RE: YIRIBANA LOGISTICS ESTATE (YLE) (SSD-10272349)

This submission has been prepared by Mirvac in relation to the Yiribana Logistics Estate (YLE) (SSD-10272349) at 754-770 and 784-786 Mamre Road, Kemps (Lot 59-60 in DP 259135).

An extract of the civil engineering cut / fill diagram for YLE Warehouse No.1 is provided below for reference.

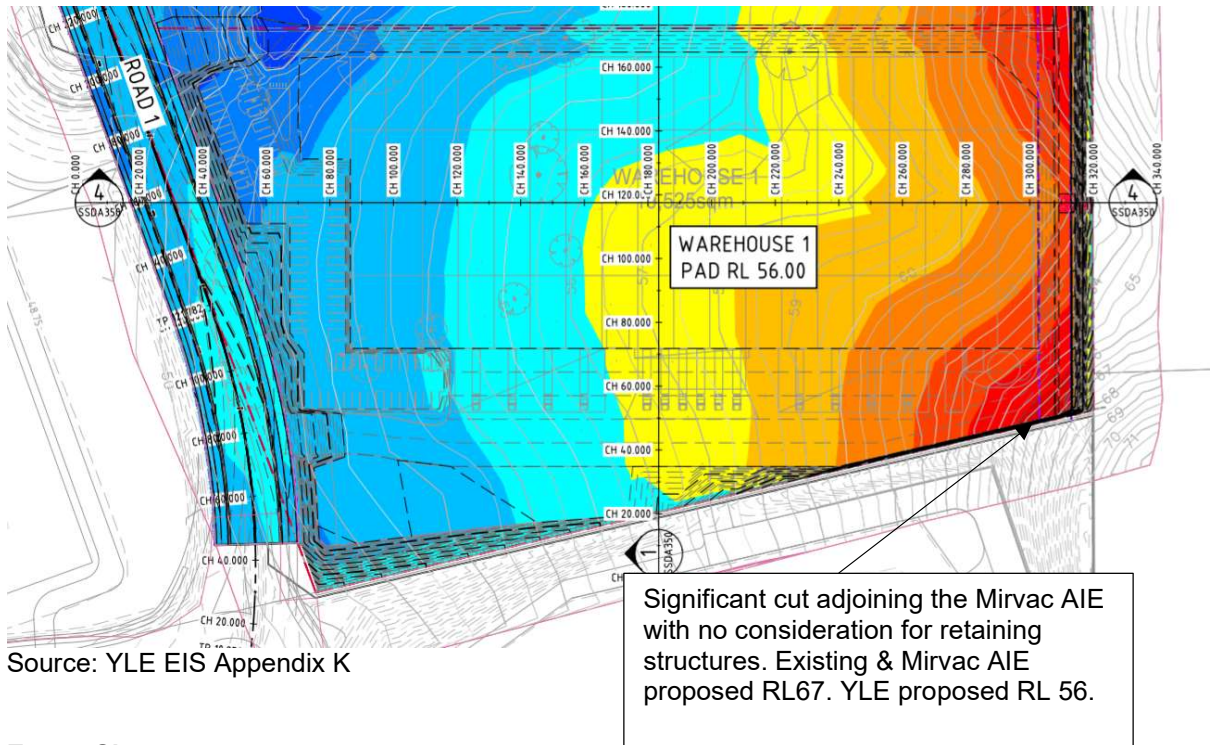
The YLE EIS states the location and indicative heights of retaining walls are provided in the Civil Drawings located within Appendix K. The civil design documentation demonstrates an approximately 11m level difference to the existing levels on the northern boundary of the AIE site but does not propose any retaining wall structure to address this. Rather it seems to seek a temporary batter within the AIE. It is noted that the proposed AIE boundary levels remain unchanged from the Mirvac AIE initial SSD, RTS or subsequent information provided by Mirvac to GPT.

We raise concerns that the GPT proposal does not adequately consider the existing or proposed levels at the boundary. Further, we confirm that Mirvac do not consent to any batters or retaining wall elements (e.g. strap zones) proposed in the YLE being located within the Mirvac site. It is therefore requested that Warehouse No.1 be amended to consider boundary levels as required. Alternatively, we would welcome a meeting with GPT to determine temporary batters into the YLE which could be carried out concurrently or after the AIE works to potentially reduce the required YLE Warehouse No.1 retaining wall extents. Though this would need to be considered and approval sought as part of the YLE SSD.

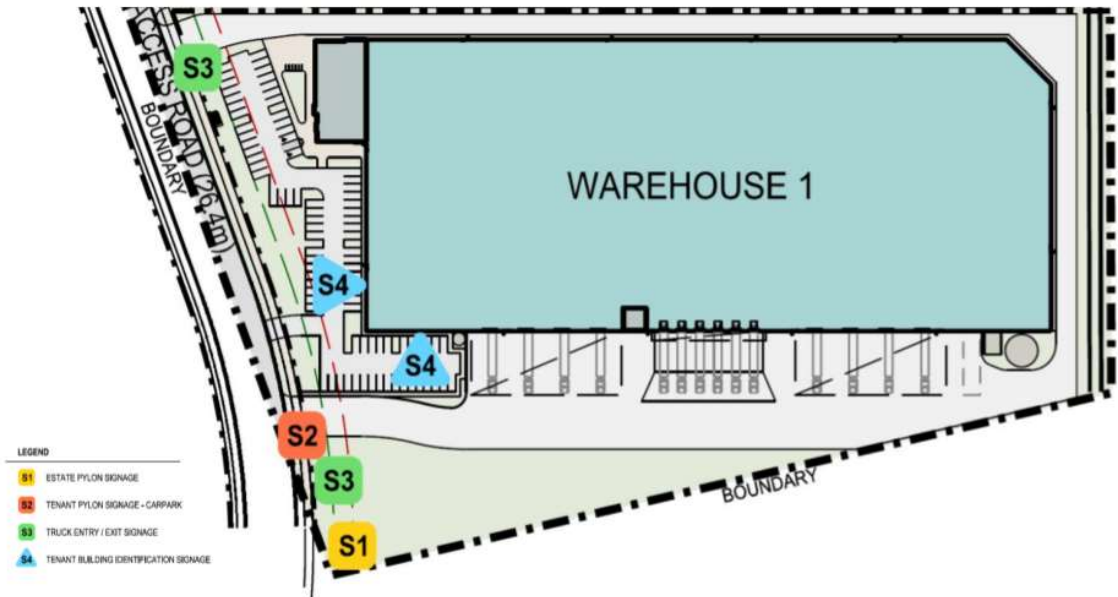
As shown within the extract below, the YLE estate pylon signage (noted as S1) is proposed at the southernmost extent of the YLE fronting Warehouse No.1.

Mirvac question whether the proposed location of the estate pylon signage is appropriate given proximity to the proposed roundabout and the potential for this to cause road user confusion. It is requested consideration be made to relocating this Pylon signage further north away from the proposed roundabout to avoid potential confusion for motorists.
